RE: Response Letter 4
Wadleigh Road, Rochester, NH
Tax Map 137, Lot 35-1
JBE Project No. 21137

We are in receipt of comments from Renee Bourdeau, P.E. At Geosyntec dated March 7, 2022. Review comments are listed below with our responses in bold.

RE: Response Letter 5
Wadleigh Road, Rochester, NH
Tax Map 137, Lot 35-1
JBE Project No. 21137

TYPICAL FOCALPOINT PLANTINGS

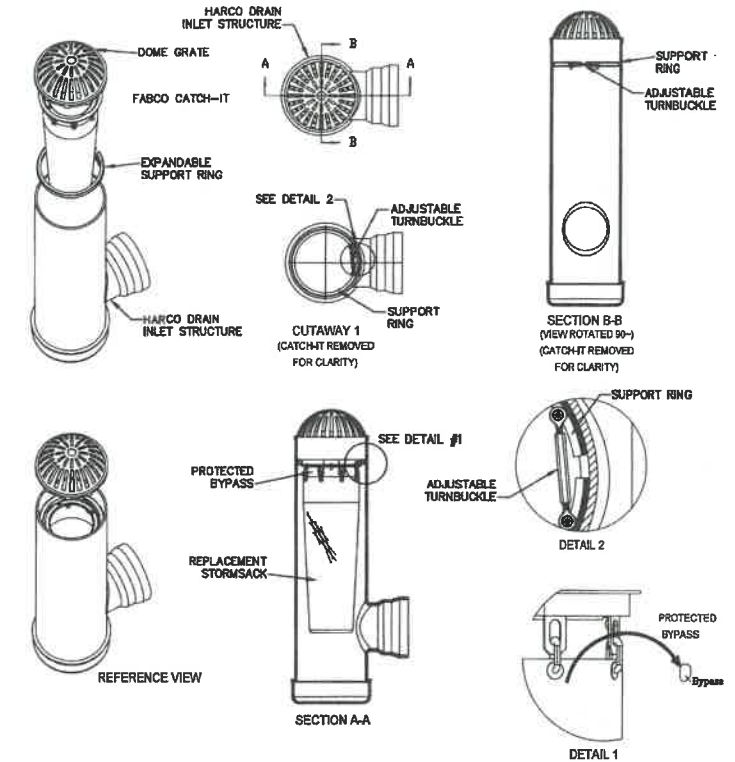
3. *The planting plan specifies use of a 3-inch layer of mulch. An alternative to hardwood bark mulch should be considered as this tends to float, not reduce erosion at the inlet, and clog overflow structures.*

RESPONSE: The type of mulch specified within the focal points is specified by the manufacturer, ACF Environmental.

PRECAST RIGID FRAME BOX CULVERT W/ WINGWALLS

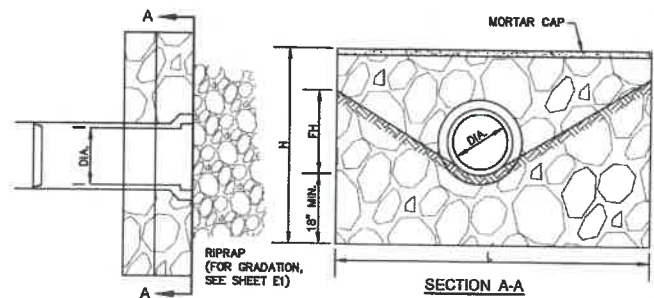
15. *The Applicant has not provided a detail schedule for the Pret-X filters. Bedding material specified for the Precast Rigid Frame Box Culvert should be consistent with native stream bed materials. The Applicant should provide material specifications consistent with recommendations from the New Hampshire Stream Crossing Standards. The Applicant should demonstrate that material specifications are consistent with recommendations from the New Hampshire Stream Crossing Standards, as noted in comment IV.2 above.*

We have reviewed the design with our Environmental Consultant and it was determined that we don't have a stream crossing so there are no native stream bed materials present to replace. We are replacing an existing culvert under the gravel access road with box culvert.

E1

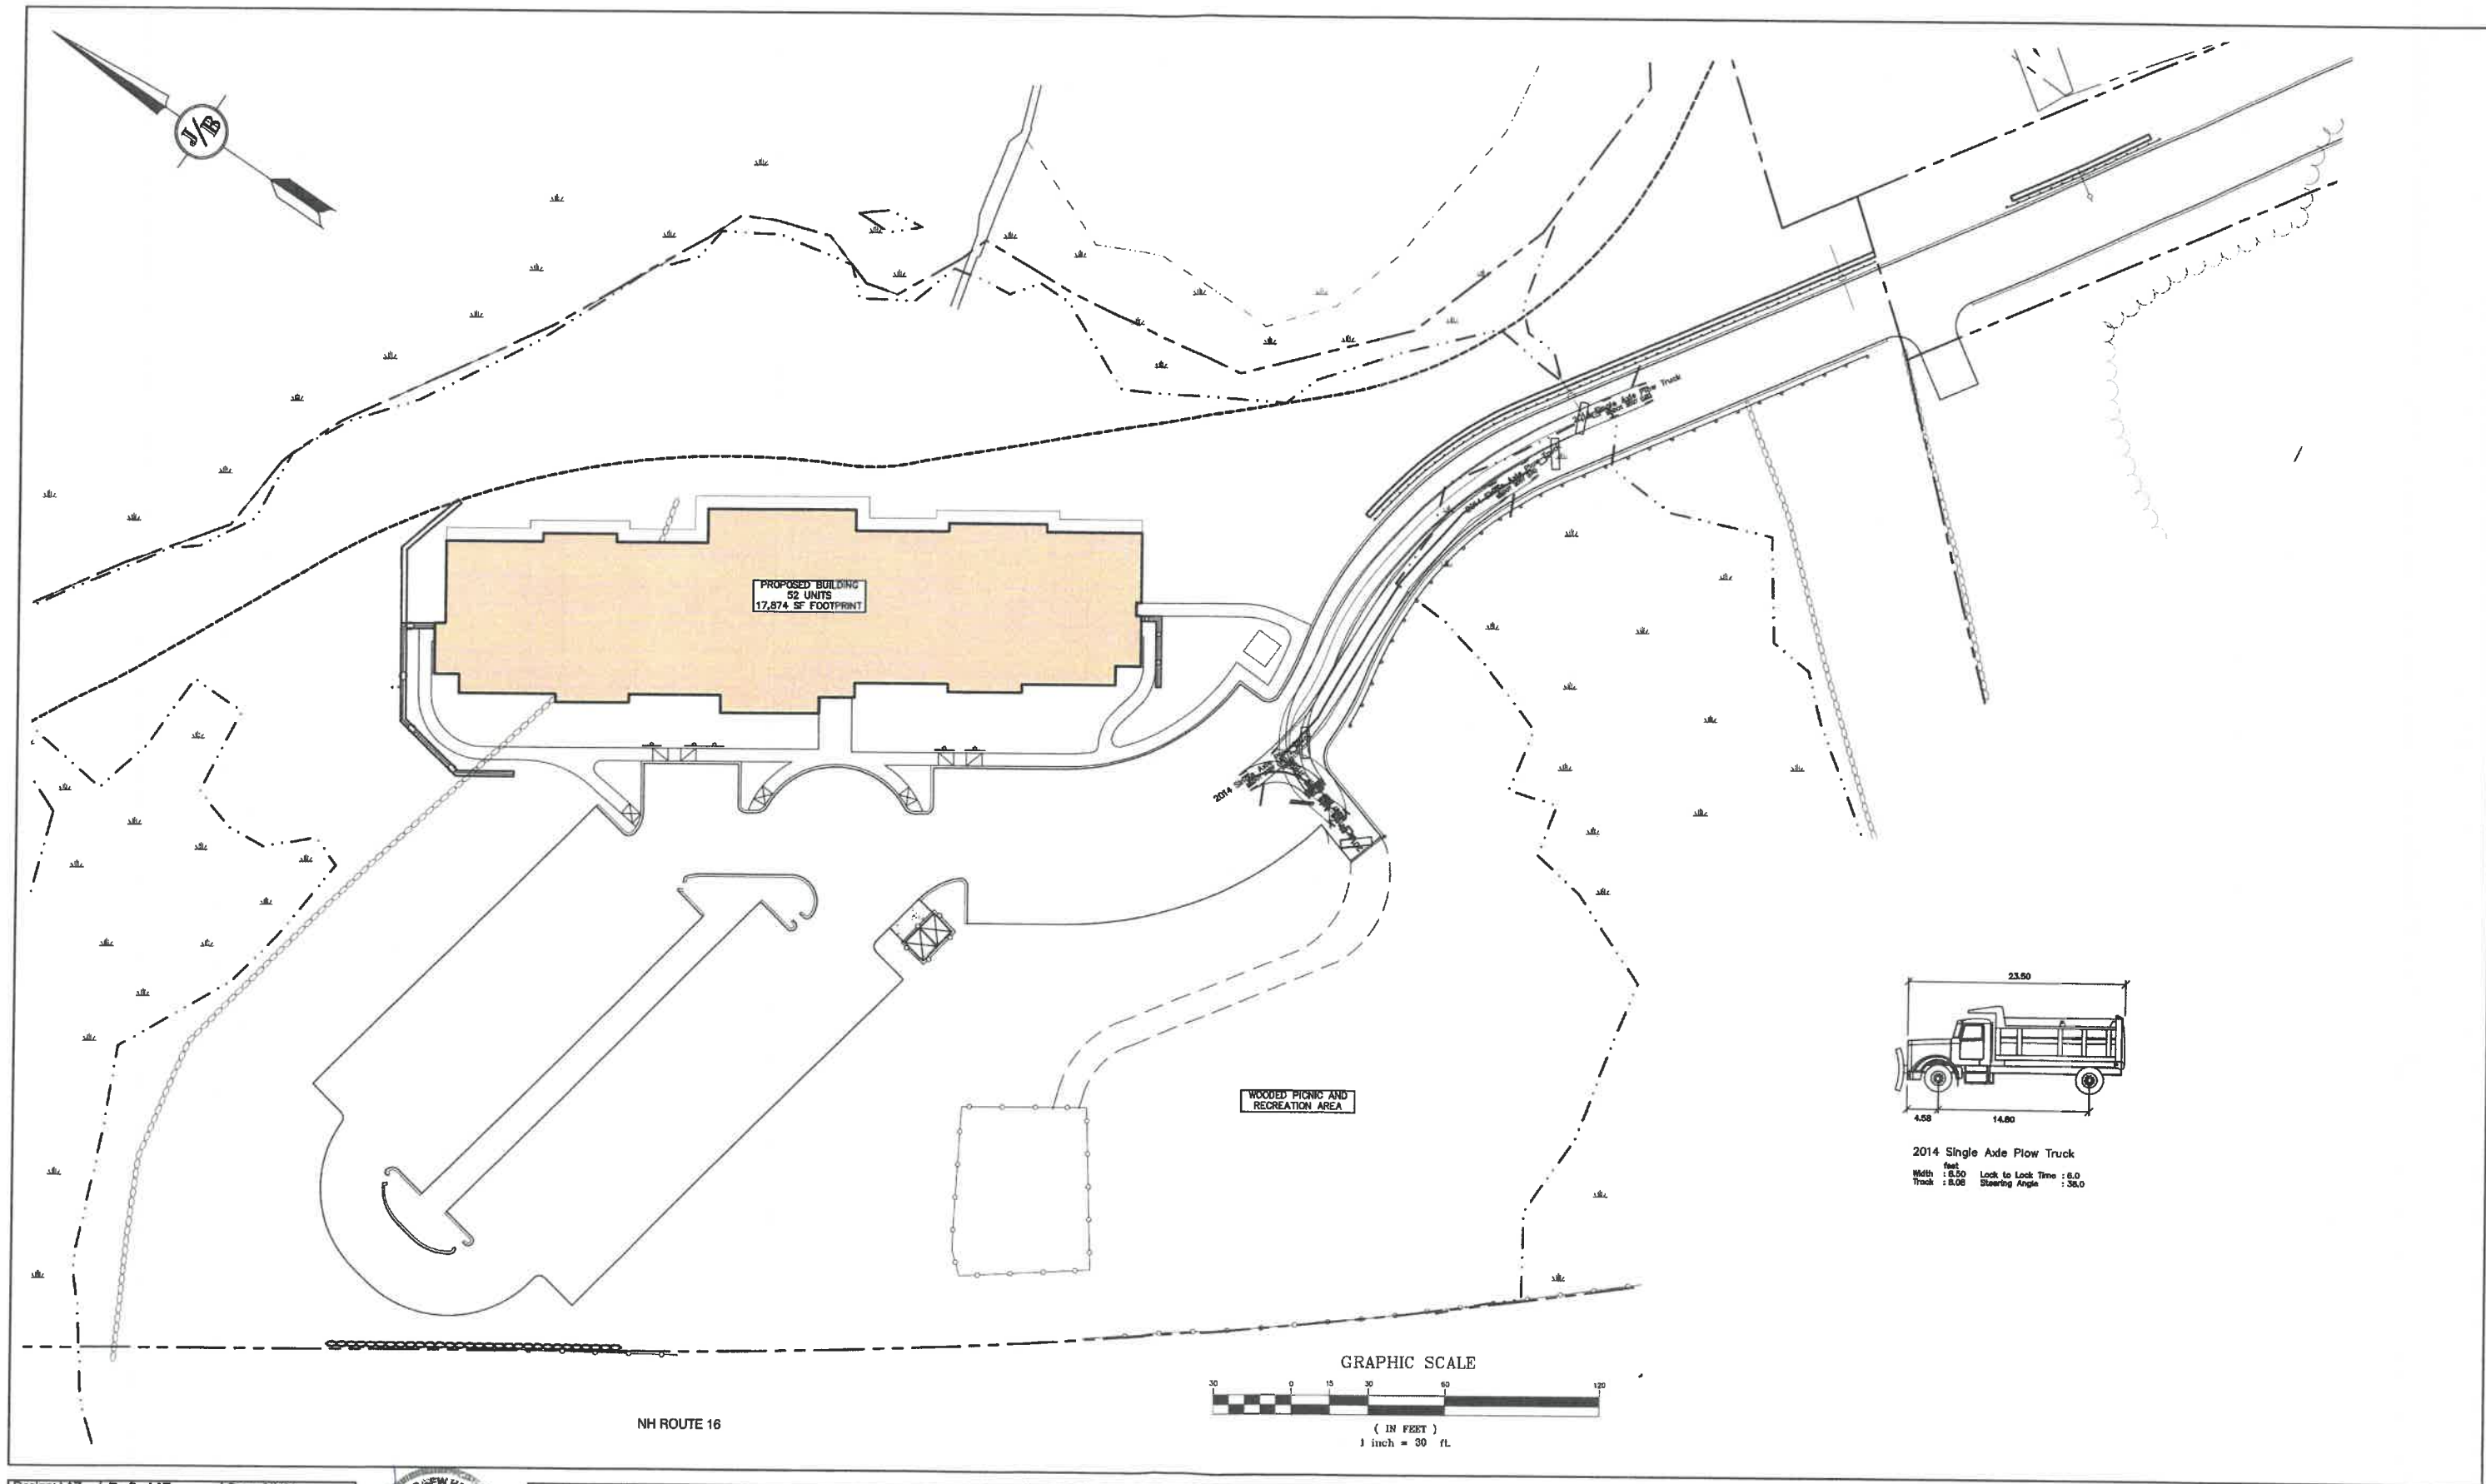
2. *Stabilization notes on the site plans and within the Drainage Analysis Report should be updated to reflect the requirements under § 218-9.A(8)(a), which state that temporary stabilization measures should be in place within 5 calendar days for exposed soil areas that are within 100-feet of a surface water body or a wetland.*

The Drainage Analysis Report does not include this stabilization note and Sheet E1 was not included in the Response Letter 3 document.

1. *On page E1, indicate that winter stabilization requirements shall be in effect from October 15th until May 15th of each year*
RESPONSE: This note has been added to Sheet E1.

RESPONSE: The above note has been added as Note #7 to Sheet E1 and to the Drainage Report.

RESPONSE: The above note has been added as Note #7 of the Temporary Erosion Control Notes on Sheet E1.
